**DOCUMENT 00 90 00  
ADDENDUM**

**ADDENDUM NO. [2]                      Date: January 19, 2018**  
**RE:                      ABBOTSFORD SCHOOL DISTRICT**  
**ELEMENTARY & MIDDLE SCHOOL ADDITION**  
**510 HEMLOCK STREET**  
**ABBOTSFORD, WISCONSIN 54405**  
**HSR PROJECT NO. 17060**

**1 MIDDLE SCHOOL FLOOR PLAN**  
1/8" = 1'-0"

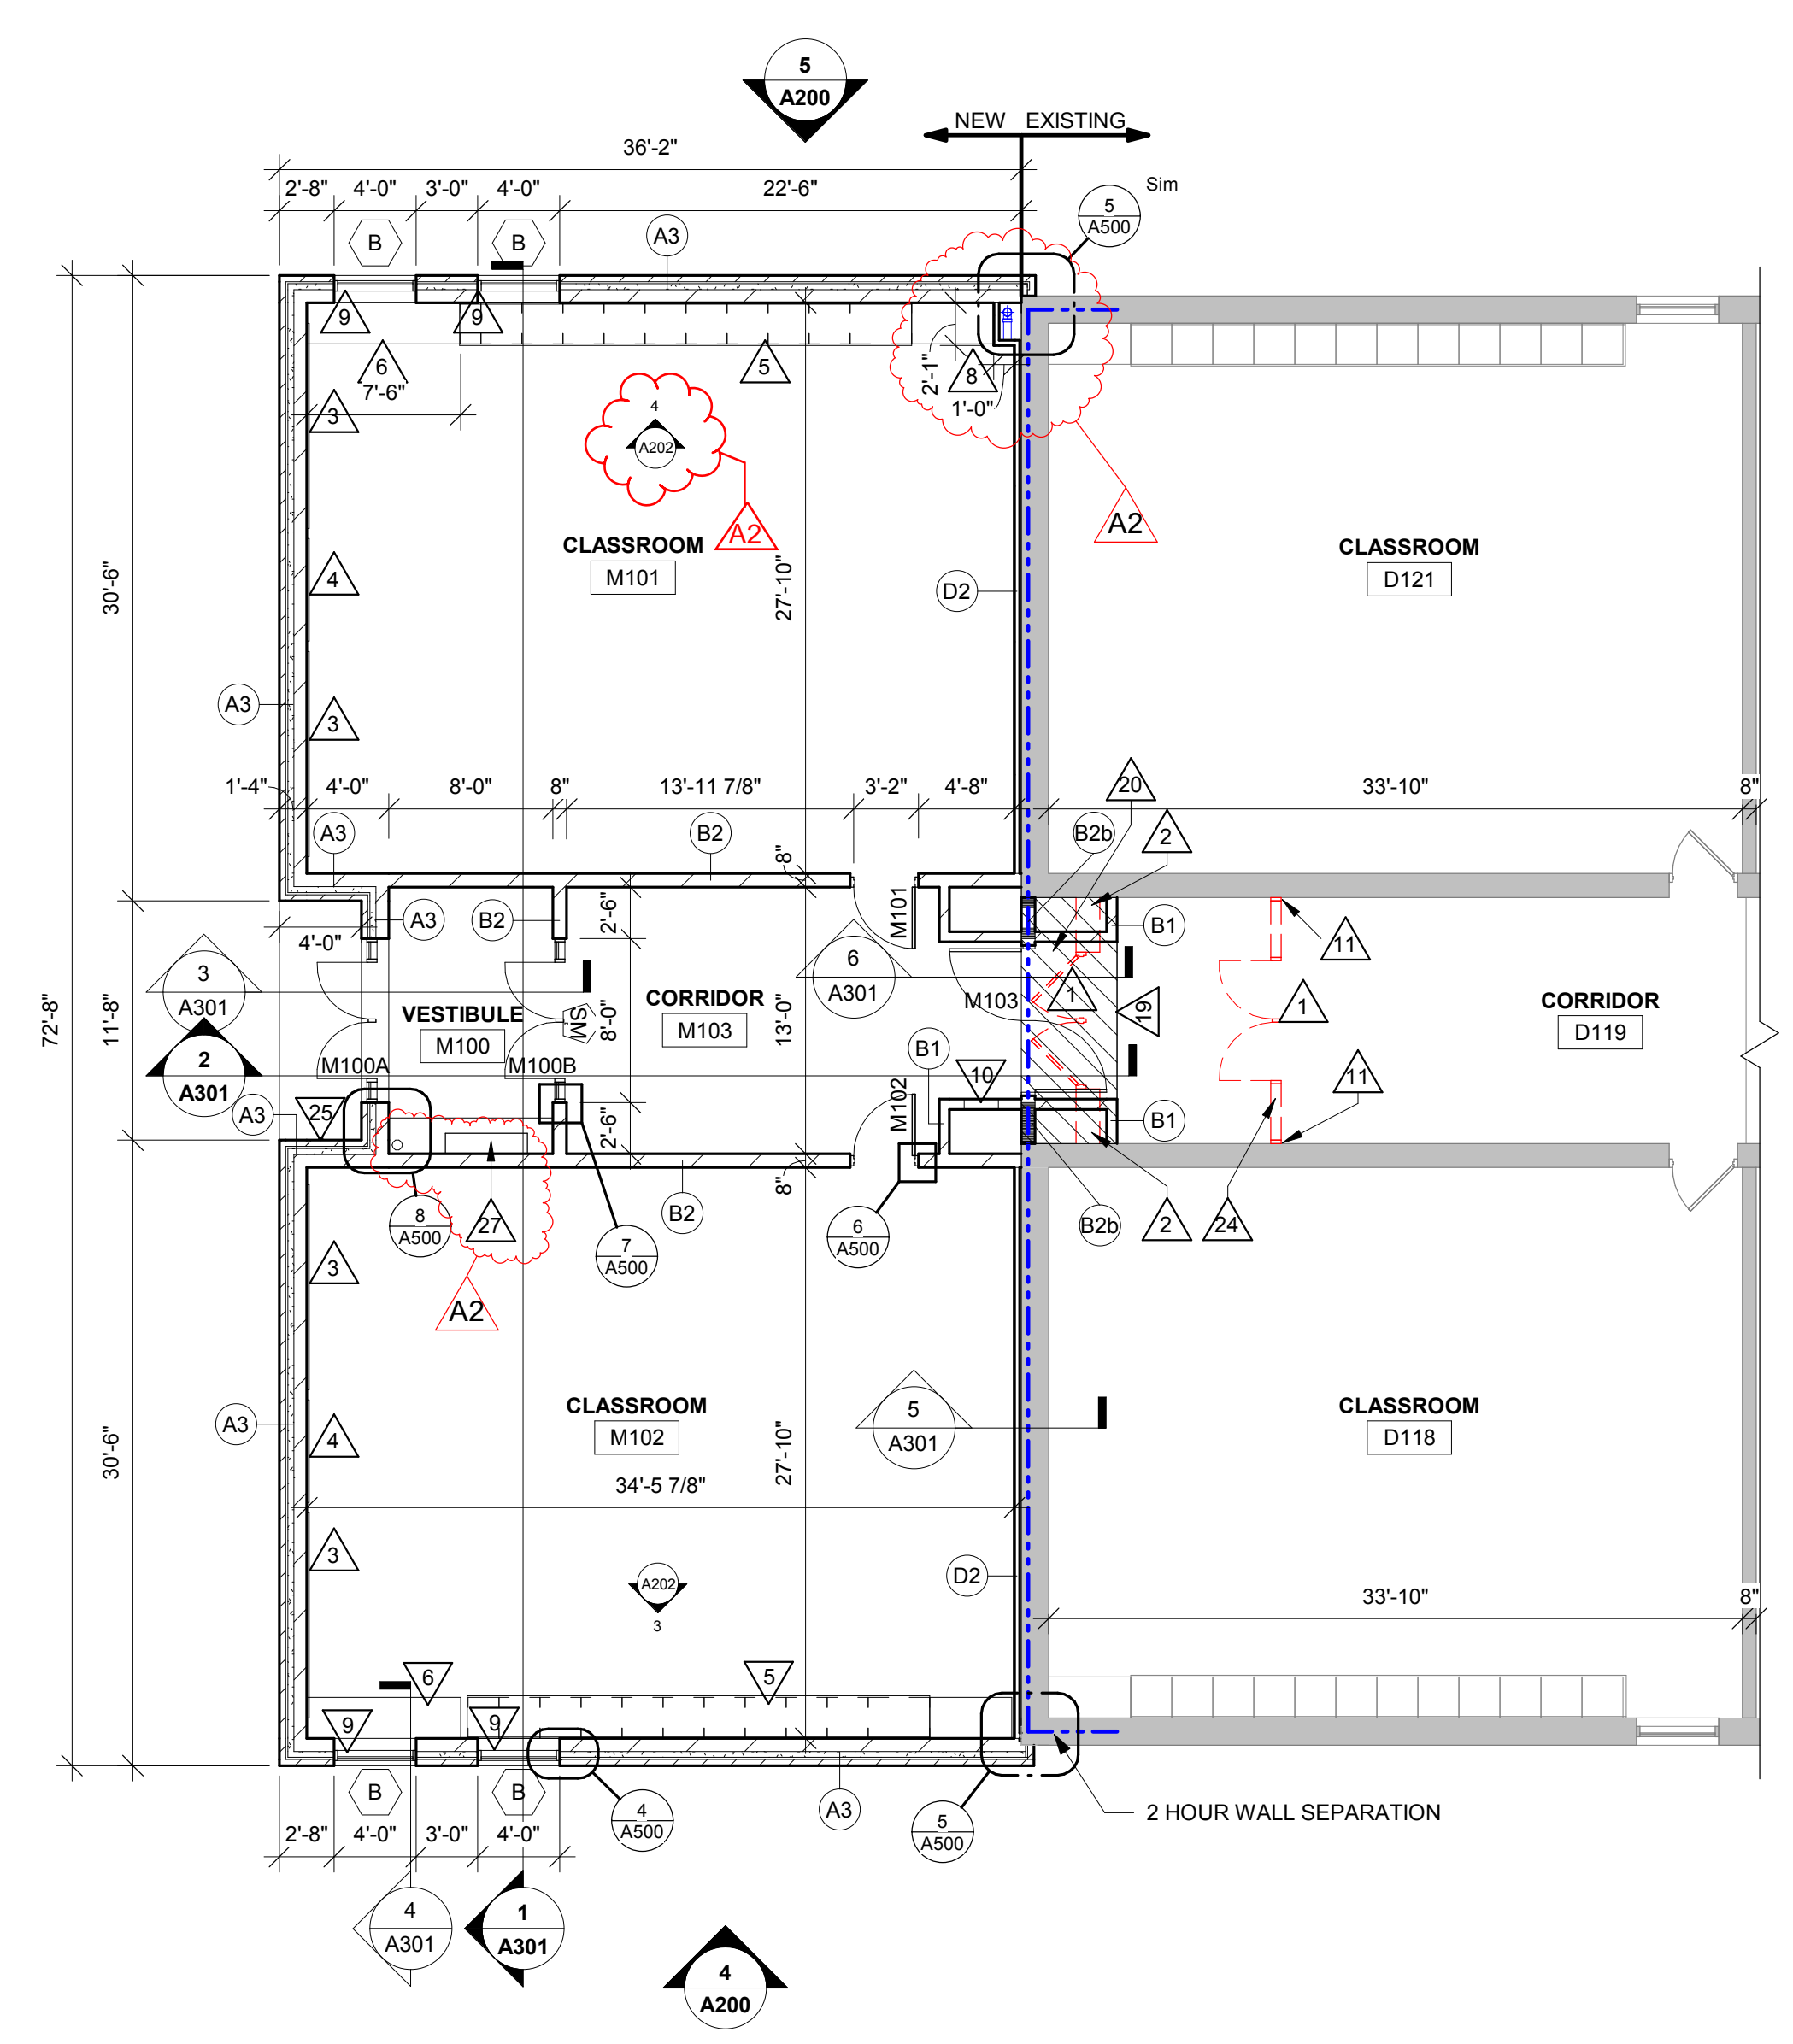
14. Sheet A101R MIDDLE SCHOOL FLOOR PLAN 30 x 42 attached hereto
  - a. Revisions clouded on plan.

**5** ELEM. HALL CUBBIES  
1/4" = 1'-0"

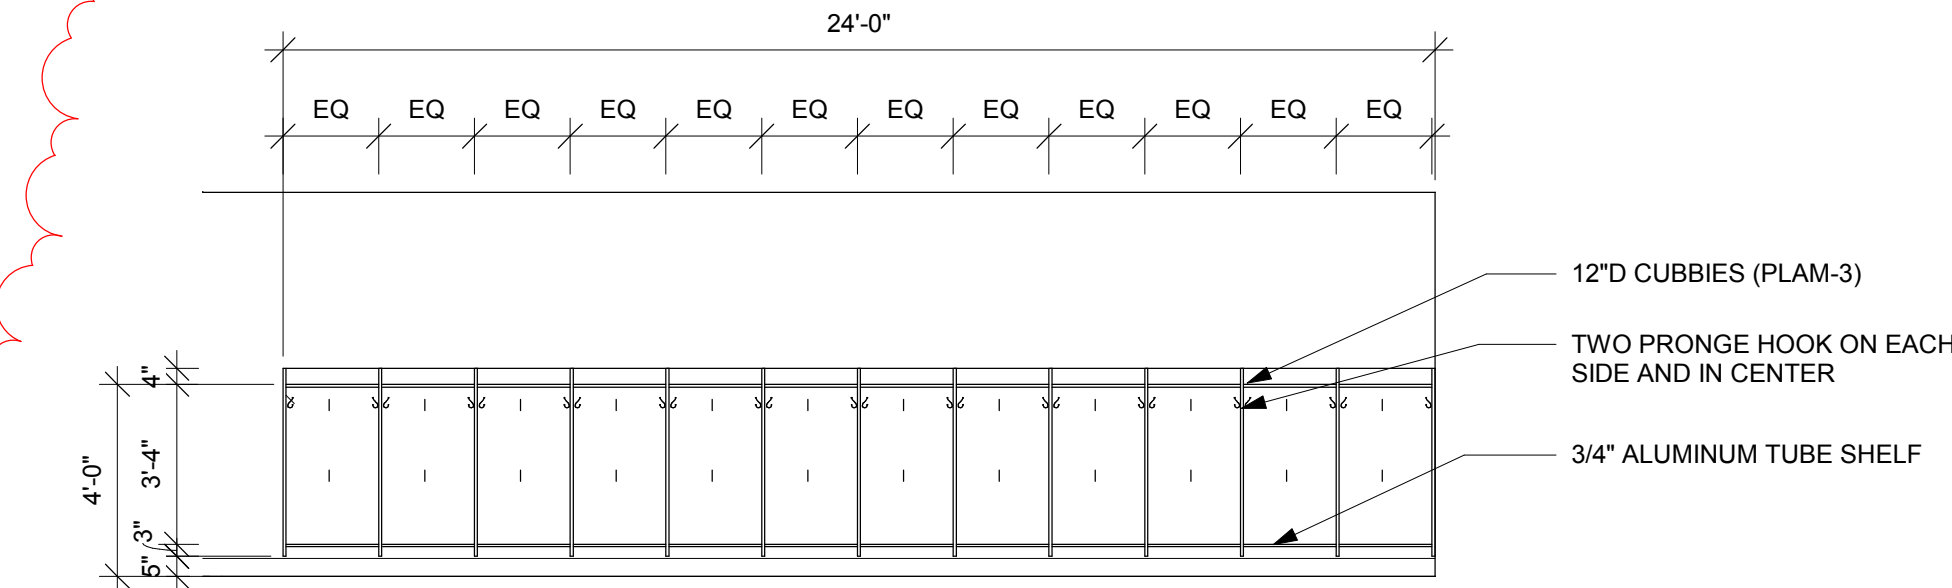
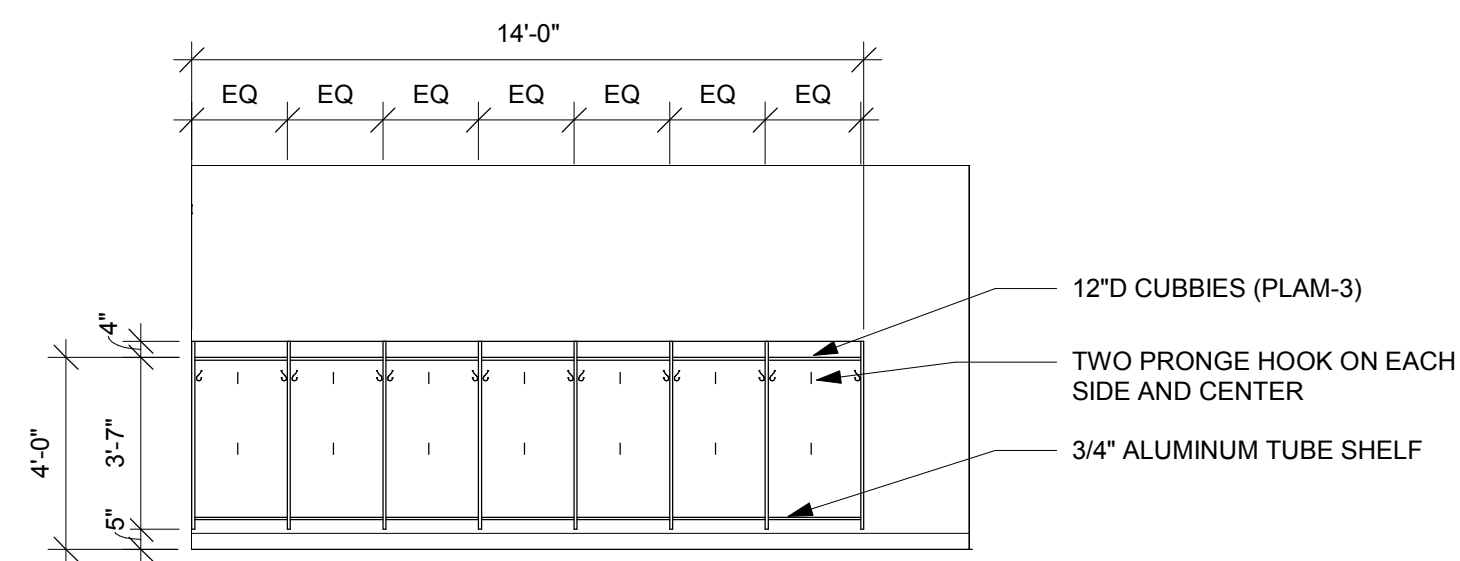
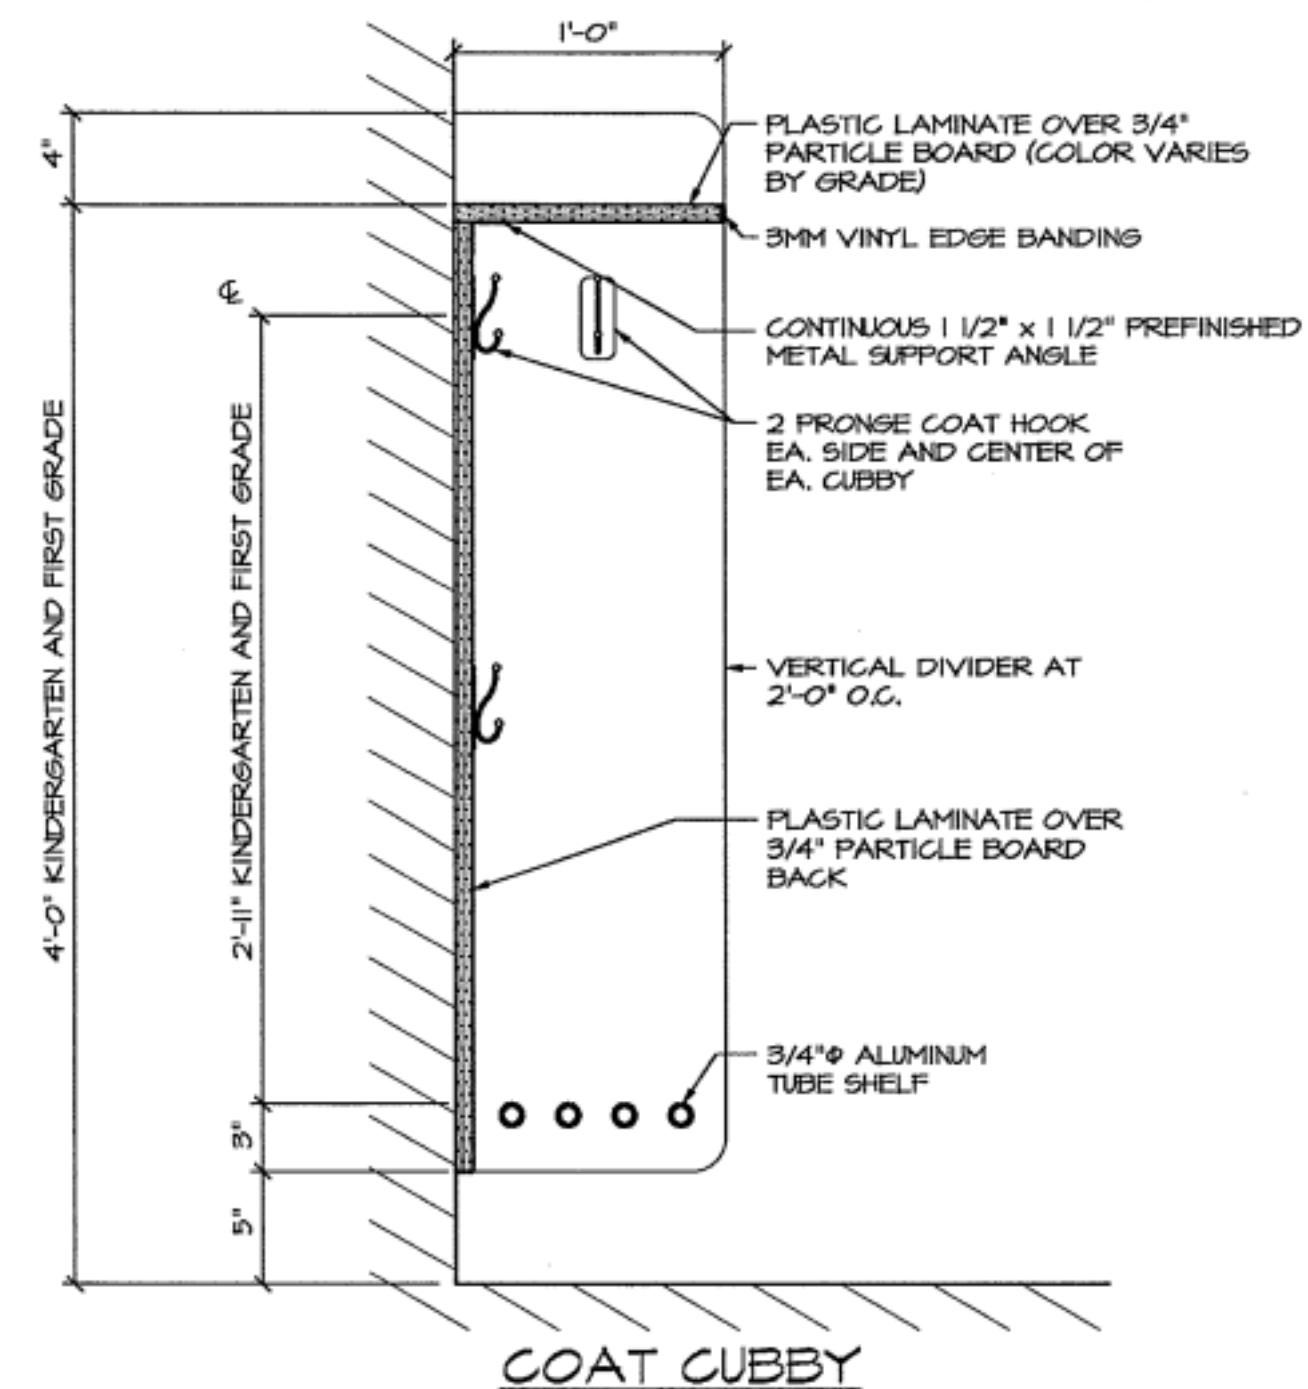
- a. 5 and 6A202 revised and section of cubbies included. Aluminum tubes shall be at greatest continuous length possible.
17. Sheet ID600 MASTER COLOR SCHEDULE

**1 ELEMENTARY SCHOOL ROOF FRAMING PLAN**  
1/8" = 1'-0"

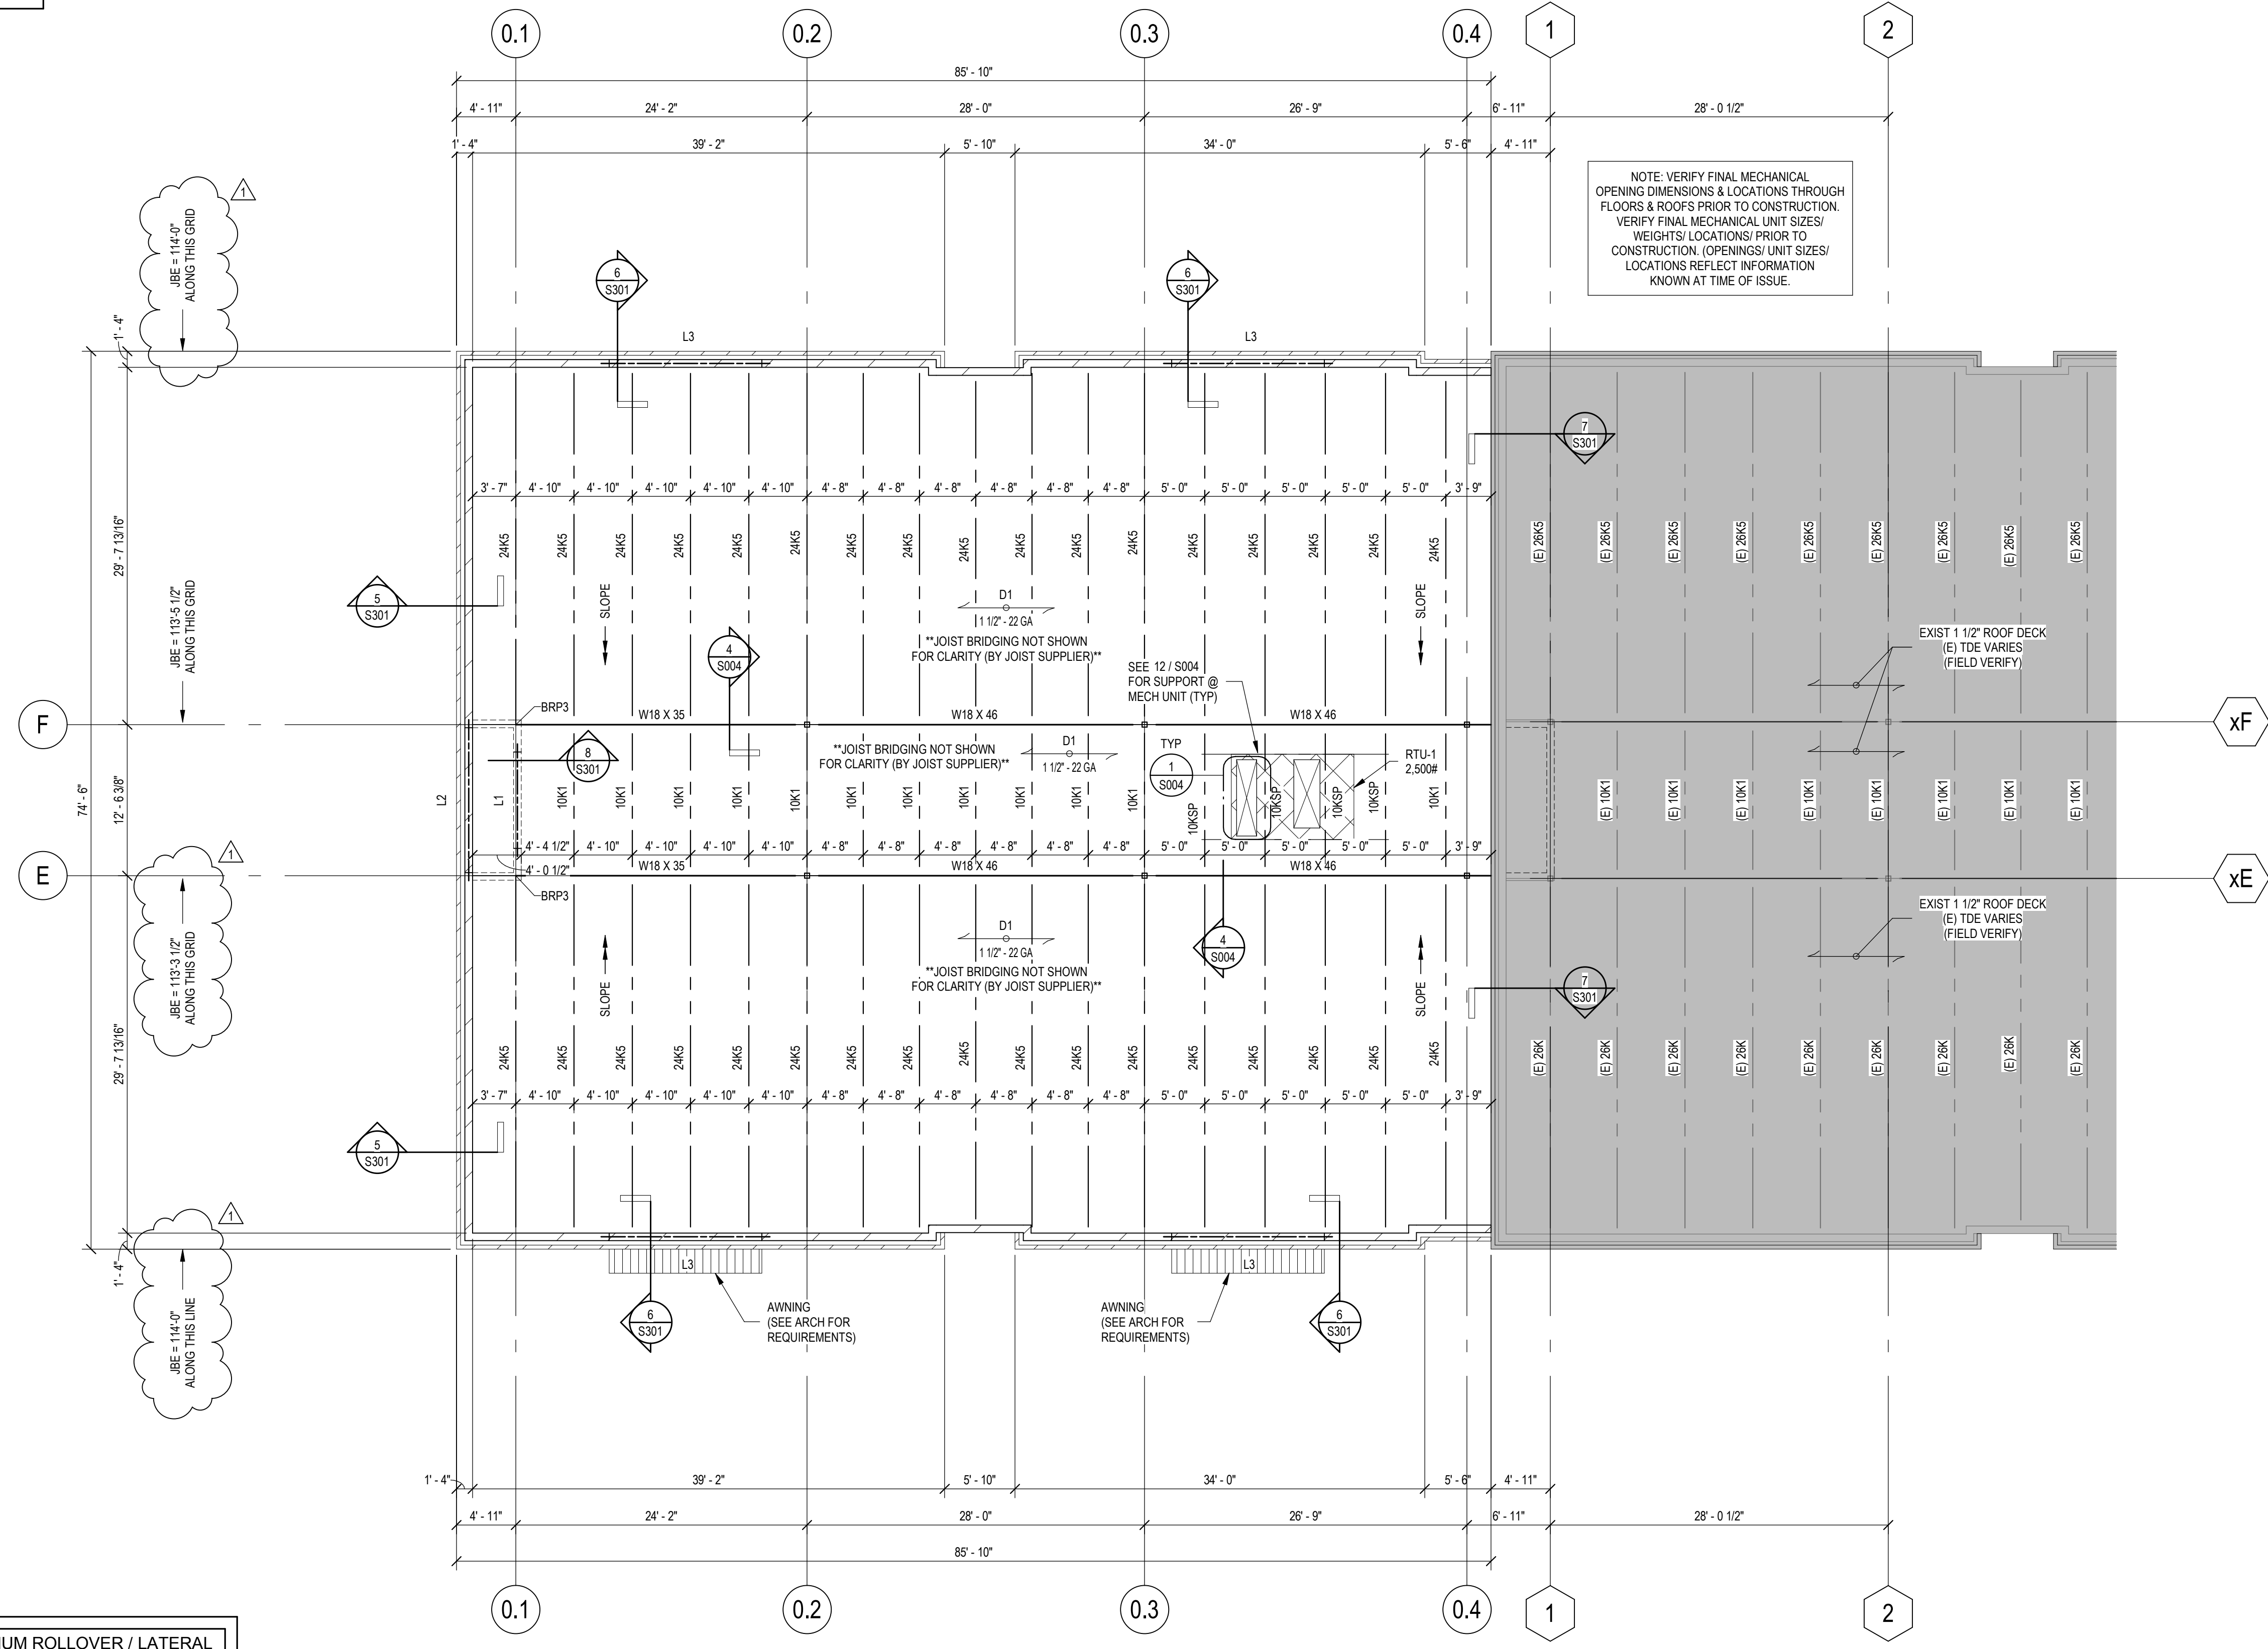
- a. Joist bearing elevations adjusted.
19. Sheet P100R PLUMBING REMODEL PLAN 30 x 42 attached hereto
  - a. 1P100: At elementary Storage 187, refer to A100 for extents of concrete floor removal for new piping.
